**Re: City of Dietrich Environmental Information Document Addendum  
No. 3**

Please find this letter in response to your e-mail dated December 20, 2012 requesting additional information regarding the *City of Dietrich, Water System Improvements Environmental Information Document (EID)*. The Finding of No Significant Impact (FONSI) was issued by DEQ on April 13, 2012. A FONSI reaffirmation determination was made on July 30, 2012 by DEQ. This letter constitutes a letter addendum No. 3 to the EID.

Figure 1

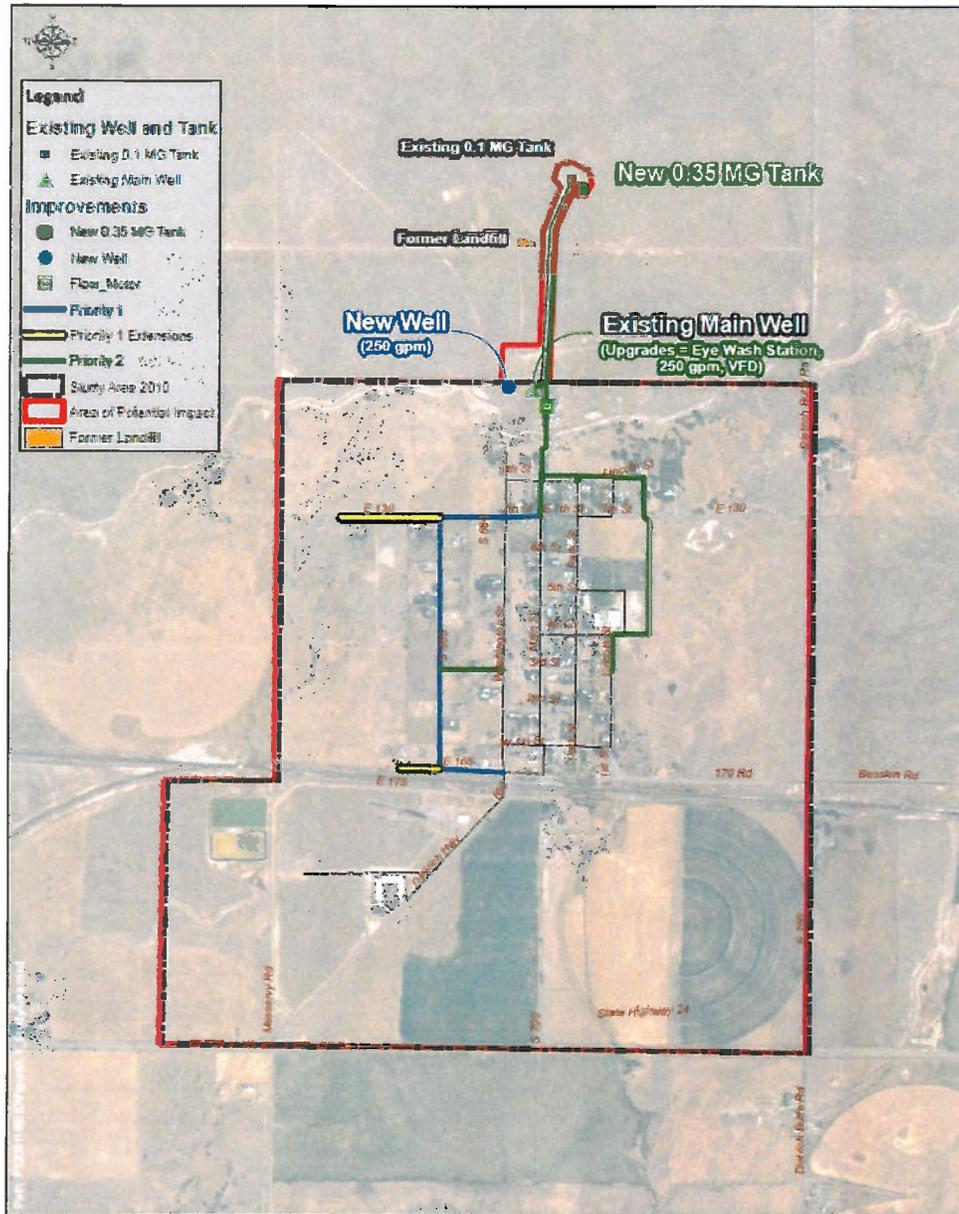
The City has requested to add two waterline extensions to the proposed project. In your letter, you requested that the two line extensions be depicted on the overall project map. Figure 1 below, which appeared in the EID and addendum No.2, has been revised to show the two proposed line extensions, which are displayed in yellow.

The proposed northern line extension (960 feet) is inside the right-of-way of 7th Street which is a paved City road. The proposed southern line extension (380 feet) is inside the right-of-way of E 165 S (known as N Rail St) which is a gravel City road.

Figure 2

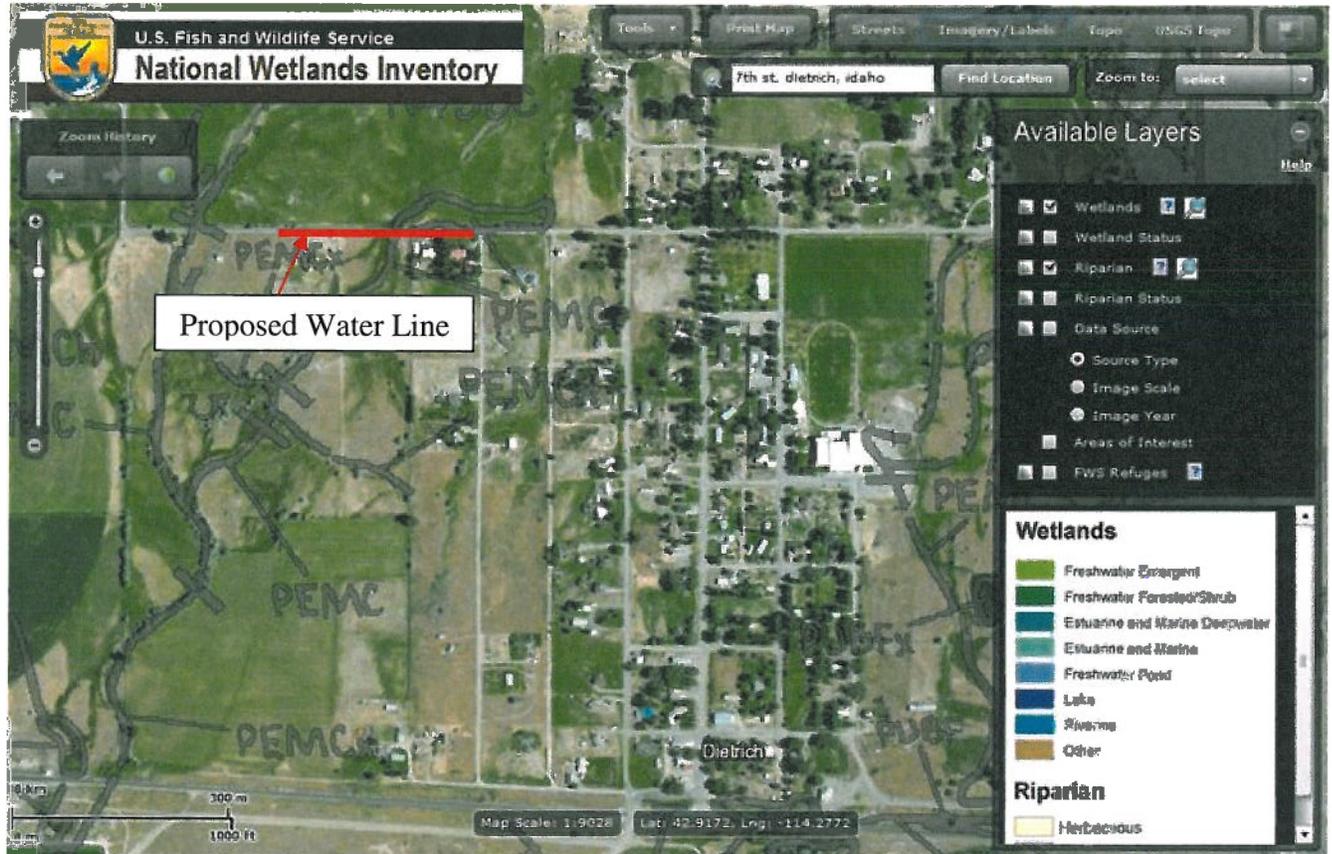
The proposed waterline improvements along 7th Street have been designed under the existing paved roadway or under the shoulder to avoid impacts to potential wetlands adjacent to the roadway shown on Figure 2. In addition, during construction activities near potential wetlands, the contractor will be required to follow several Best Management Practices (BMPs) to protect the adjacent wetland. Any construction materials will be stockpiled in staging areas away from potential wetland areas. Sediment barriers will be utilized to protect the wetland areas from sediment runoff. Contractor will be required retain and protect the existing culvert shown on Figure 3 to avoid impacts to in-stream flows or water quality conditions.

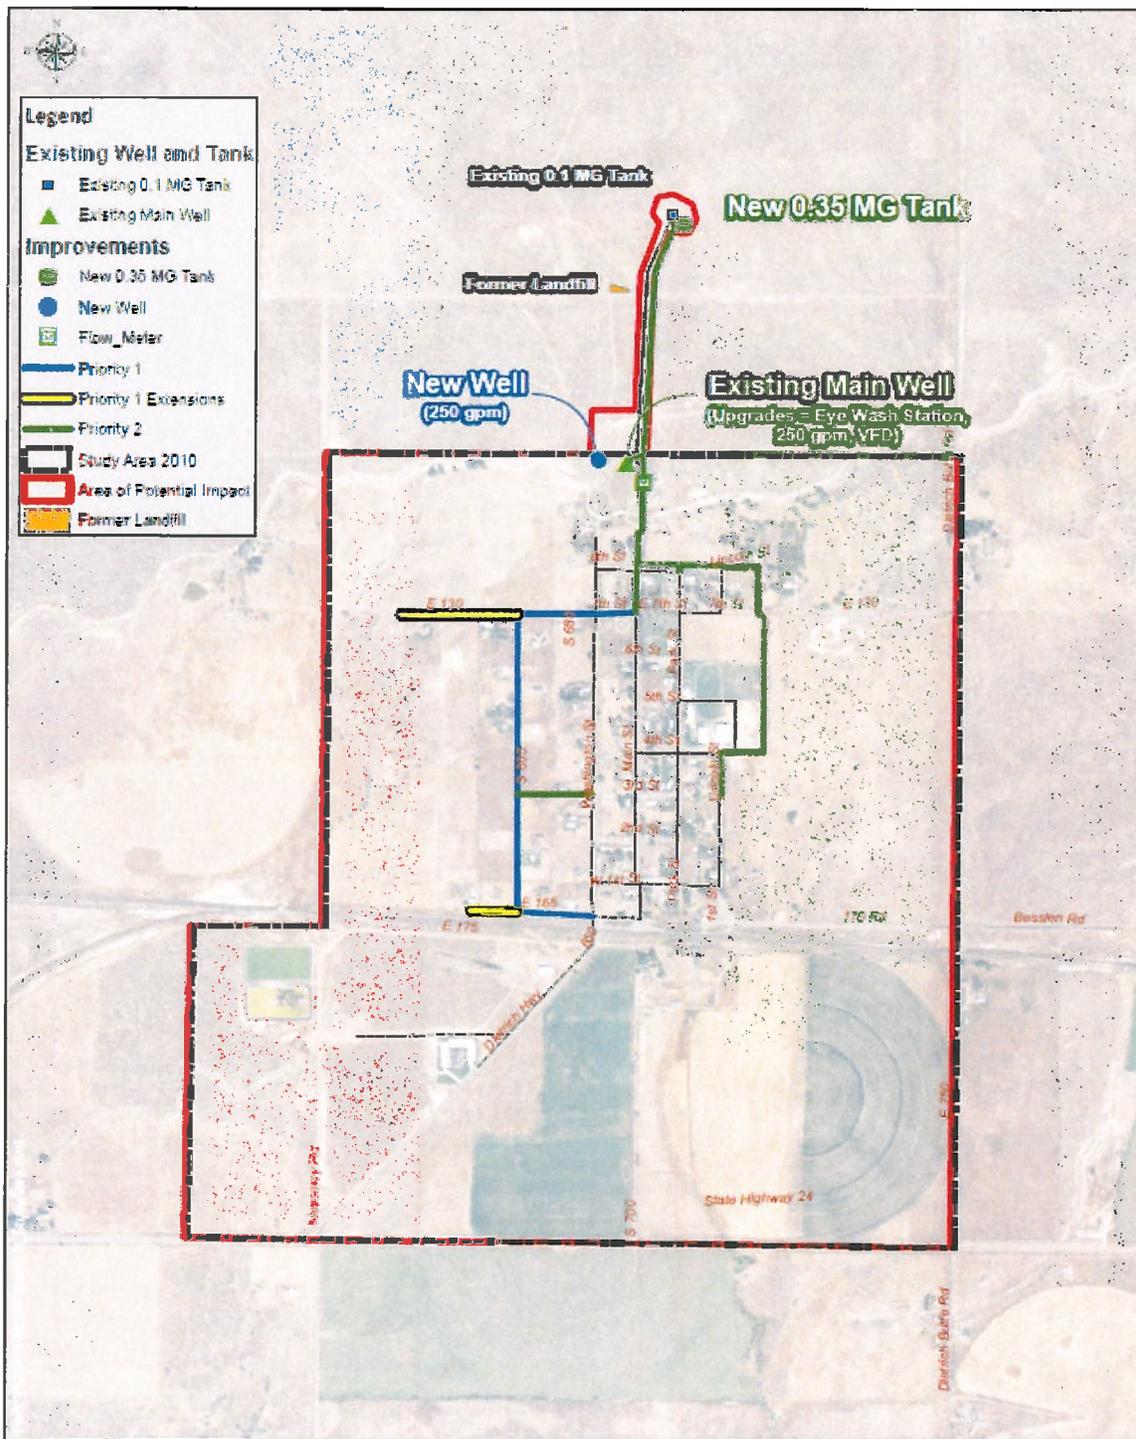
The City has requested to add two waterline extensions to the proposed project. In your letter, you requested that the two line extensions be depicted on the overall project map. Figure 1 below, which appeared in the EID and addendum No.2, has been revised to show the two proposed line extensions, which are displayed in yellow.

The proposed northern line extension (960 feet) is inside the right-of-way of 7th Street which is a paved City road. The proposed southern line extension (380 feet) is inside the right-of-way of E 165 S (known as N Rail St) which is a gravel City road. Given the absence of habitat, nature of the improvements, and proposed construction techniques, we do not believe there are any negative environmental impacts to the proposed waterline extensions. Please contact me at 208-288-1992 with any questions. Thank you.

Figure 1

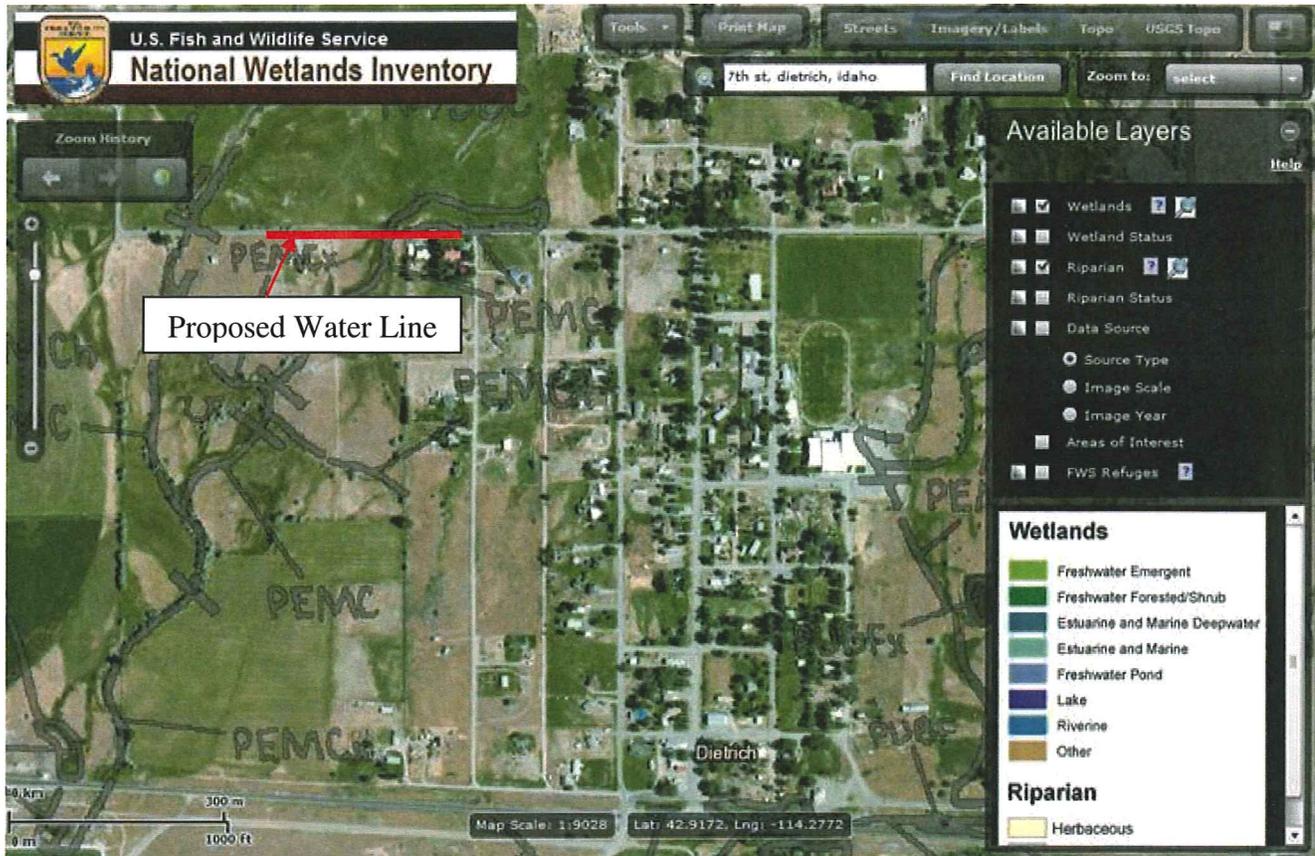
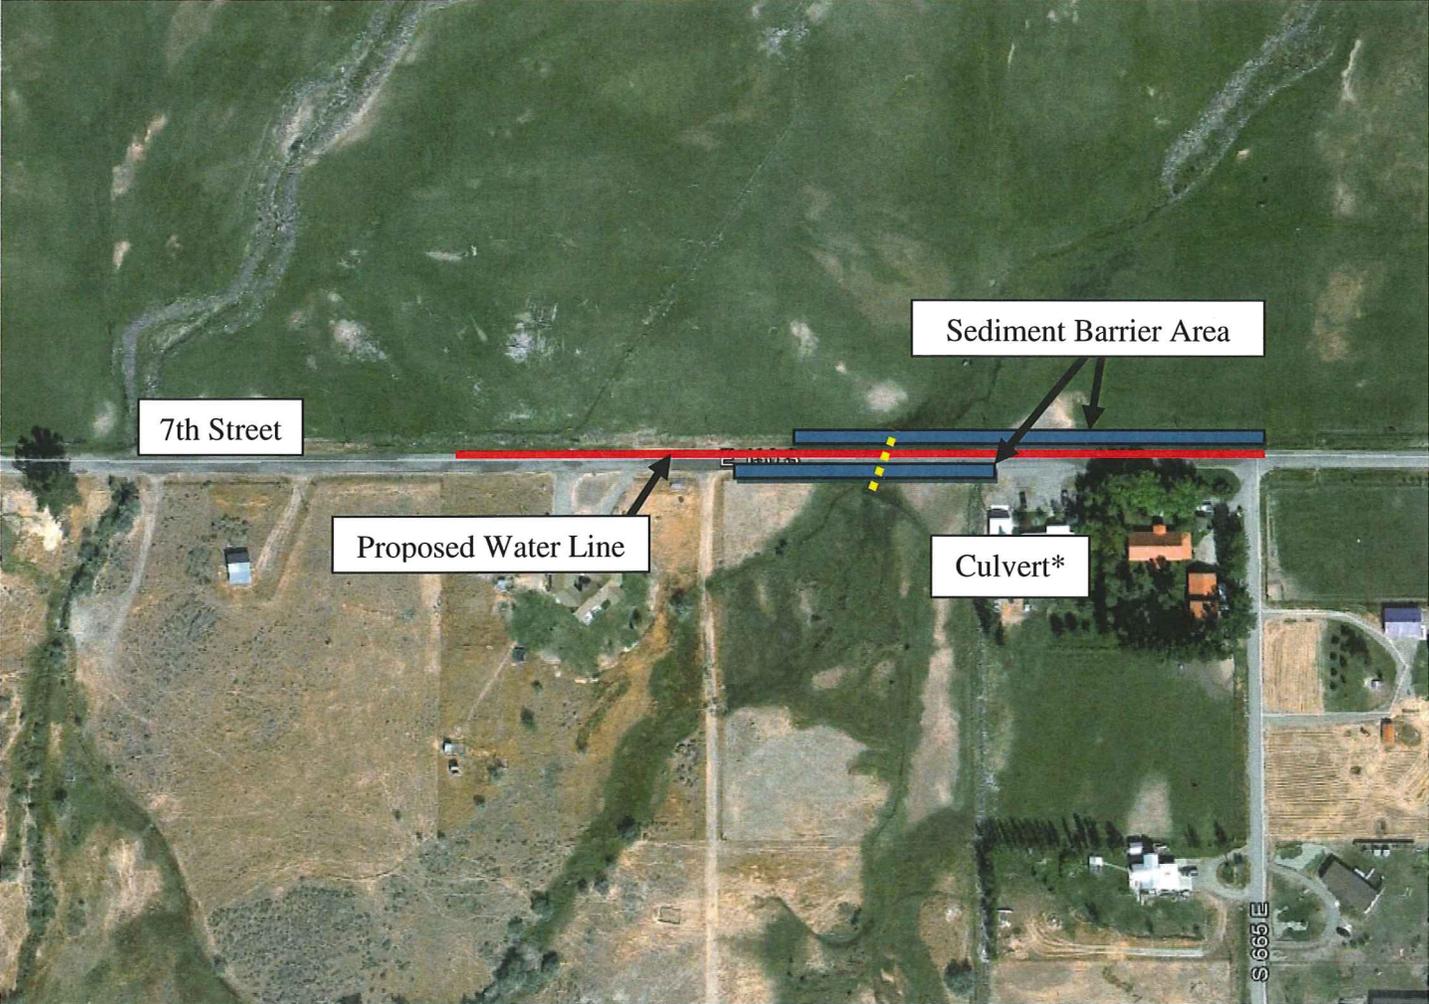
We are writing this letter in behalf of the City of Dietrich as the engineering design professional for the City's water improvement project planned later this summer and fall. We are writing to inform you that a waterline extension along 7th Street shown on Figures 1 and 2 below is part of the proposed project improvements. The proposed waterline has been designed under the existing paved roadway or under the shoulder to avoid impacts to potential wetlands adjacent to the roadway shown on Figure 2. The actual waterline crossing with the drainage path will occur under an existing pipe/culvert crossing under the roadway.

In addition, during construction activities near potential wetlands, the contractor will be required to follow several Best Management Practices (BMPs) to protect the adjacent wetland. Any construction materials will be stockpiled in staging areas away from potential wetland areas. Sediment barriers will be utilized to protect the wetland areas from sediment runoff. Contractor will be required to retain and protect the existing culvert shown on Figure 3 to avoid impacts to in-stream flows or water quality conditions. No construction activities are proposed in the drainage area or adjacent wetlands. Consequently, a Joint 404 permit will not be submitted. Please notify me at 208-288-1992 if you have any questions or concerns.
